ZONING CHANGE REVIEW SHEET

CASE: C814-2018-0121 -- 218 South Lamar

ZONING FROM: CS-V

TO: PUD

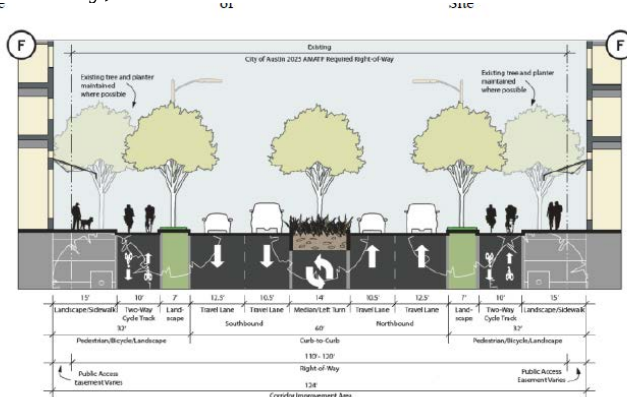
TR2. Include the below streetscape in the land use plan. Contact this reviewer for a more legible copy of it if necessary. This project is adjacent to a street that has been identified in Austin's Corridor Mobility Program (S Lamar). The sidewalk and bicycle facilities shall comply with the required cross-section at the time of the site plan application. The cross section that will be required is shown below. Find additional information about the Corridor Mobility Program here: <https://data.austintexas.gov/stories/s/Corridor-Mobility-Program/gukj-e8fh/>. Any proposed curb relocations on S Lamar requires coordination with the Corridor Planning Office and Bicycle Program. The cross section will include a 7' planting zone with street trees, a 10' two-way cycle track, and a 15' clear zone all behind curb. Additionally, a protected intersection will be required at Toomey, to be reviewed at the time of Site Plan.

4-Lane Divided, 60' Curb-to-Curb
Back-of-Curb Condition F
Barton Springs Road to Riverside Drive
